Capital Project No. WP-169
Long Term Control Plan II

**Combined Sewer Overflow
Long Term Control Plan
for
Westchester Creek
Appendix E: Supplemental Documentation**

This Supplemental Documentation contains DEP's responses to DEC's comment letter, dated January 14, 2015, on the June 2014 Combined Sewer Overflow (CSO) Long Term Control Plan (LTCP) for the Westchester Creek. The Supplemental Documentation is now made part of the referenced LTCP as Appendix E.

Figure 2-8. HP CSO Bacteria 2014 Sampling Data (Revised)

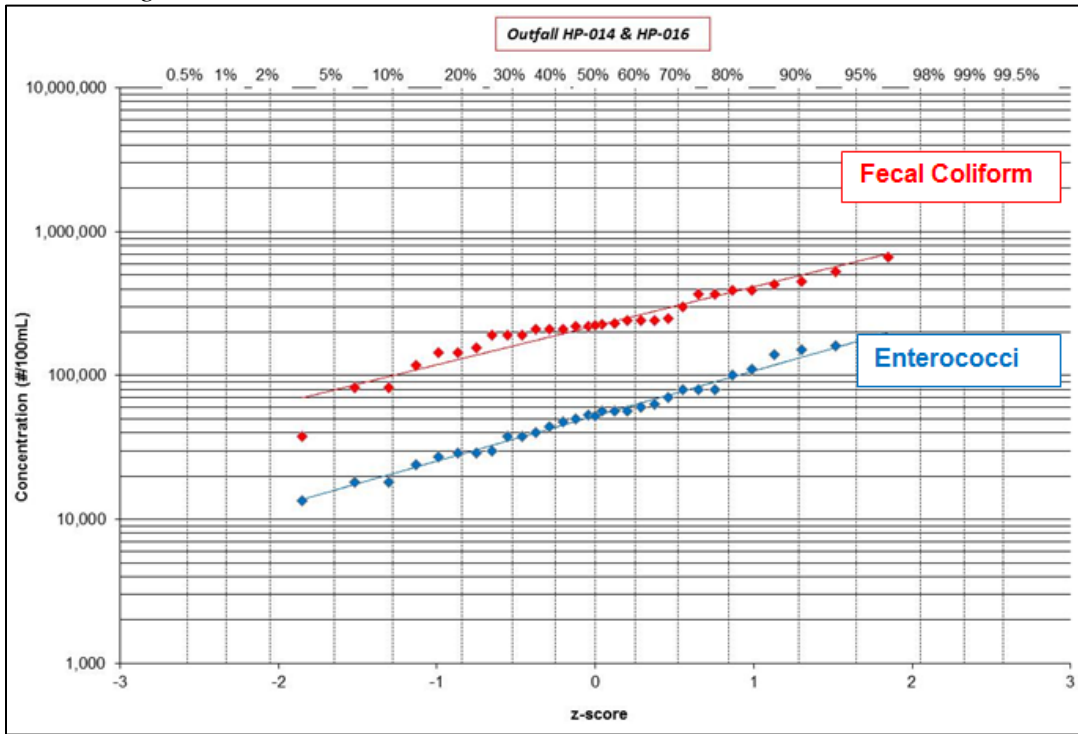
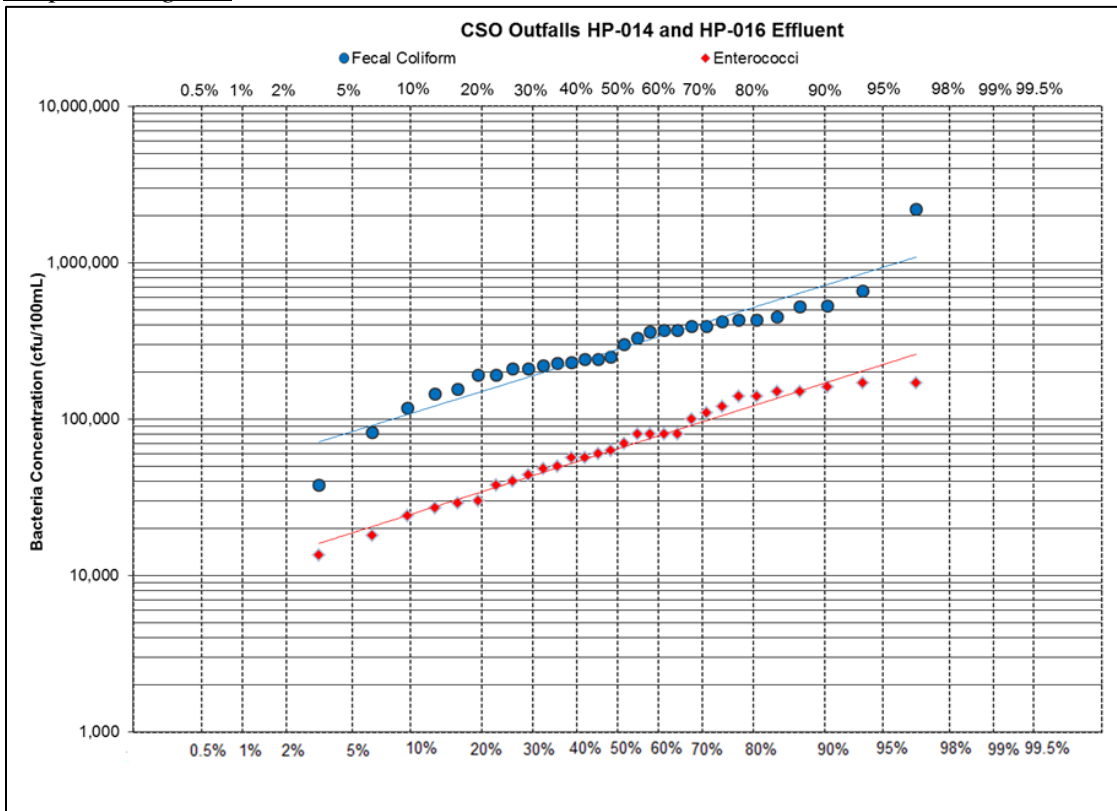
Figure 2-8 presents the fecal coliform and enterococci concentrations from the sampling of CSO Outfalls HP-014 and HP-016, however, according to the data provided to the Department in the file “Westchester Raw data for DEC May, 14, 2014”, one data point for HP-016 had a count of bacteria of over 2 million cfu/100mL. This data point does not appear to be included in Figure 2-8 and should be included to accurately to assess concentrations of CSO.

The data noted by DEC were not excluded from the analysis. The labels “Fecal Coliform” and “Enterococci” used in Figure 2-8 were mistakenly placed over a few data points with low return frequencies including the 2 million value noted by the DEC. The figure has been replaced.

Figure 4-3. Proposed WWFP Element CSO-29A Modification, Pugsley Parallel Sewer (Revised)

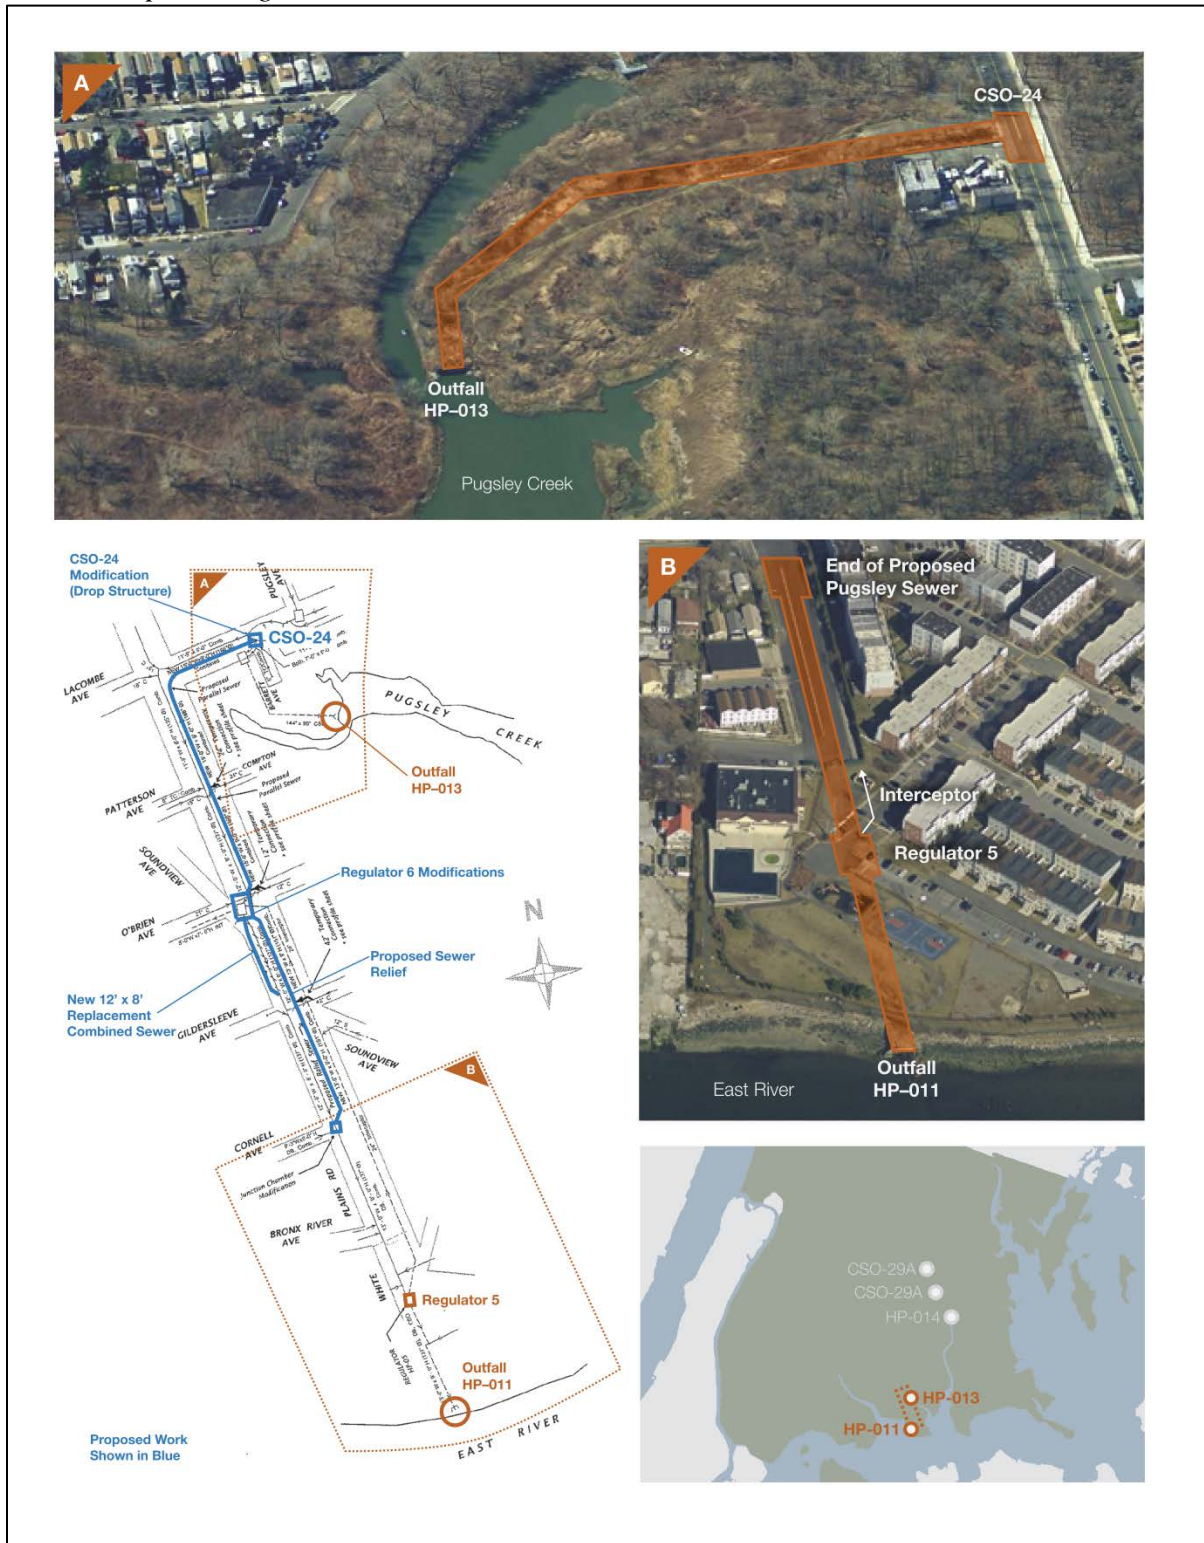
Figure 4-3 should include a more legible illustration of the parallel sewer for Pugsley Creek.

The figure has been revised.

Figure 8-2. Proposed Route of Throgs Neck PS FM Extension to Hunts Point WWTP

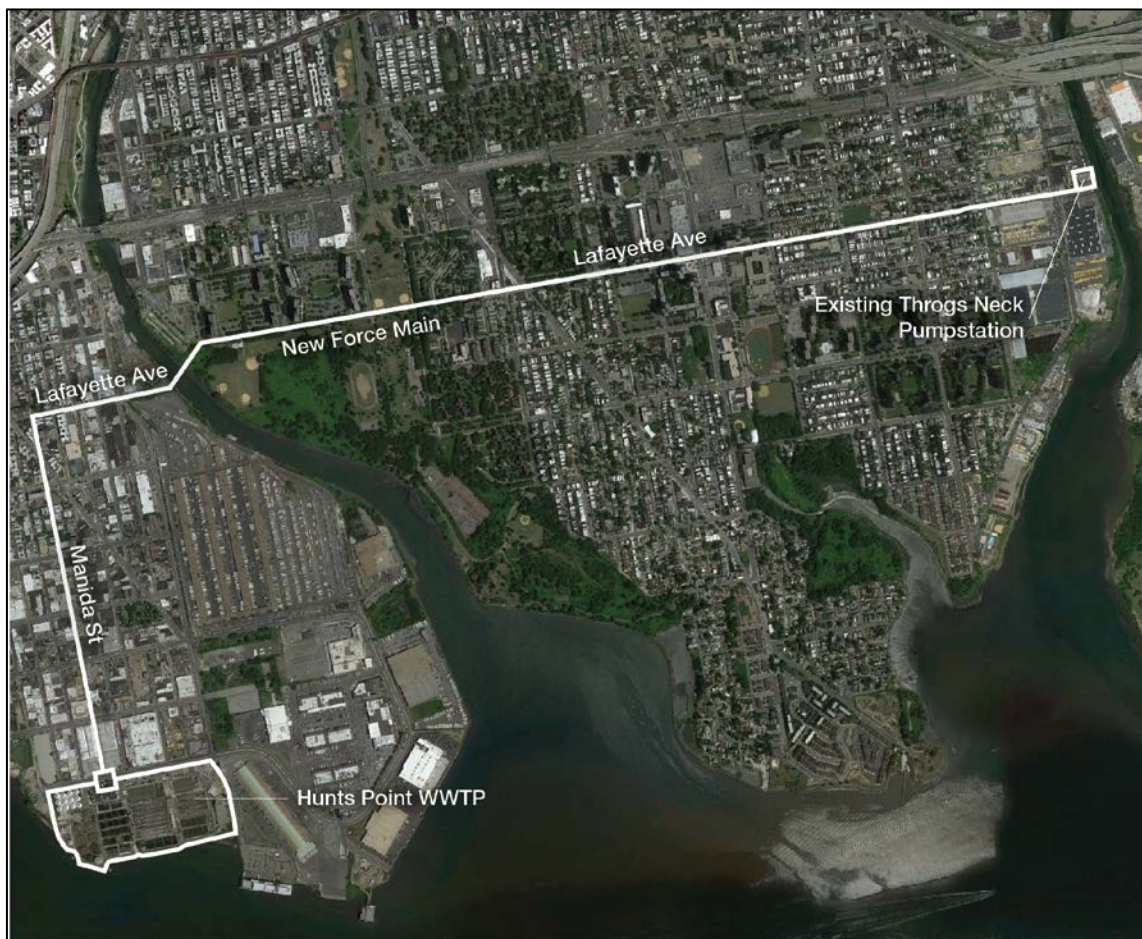
Figure 8-2 indicates that the size of the dewatering pump station for in-line storage is 509 MGD; however Table 8-2 indicates that the pump station would be 3 MGD. Reconcile the discrepancy.

The size of the pump station is 3.0 MGD; Figure 8-2 and Table 8-2 have been reconciled.
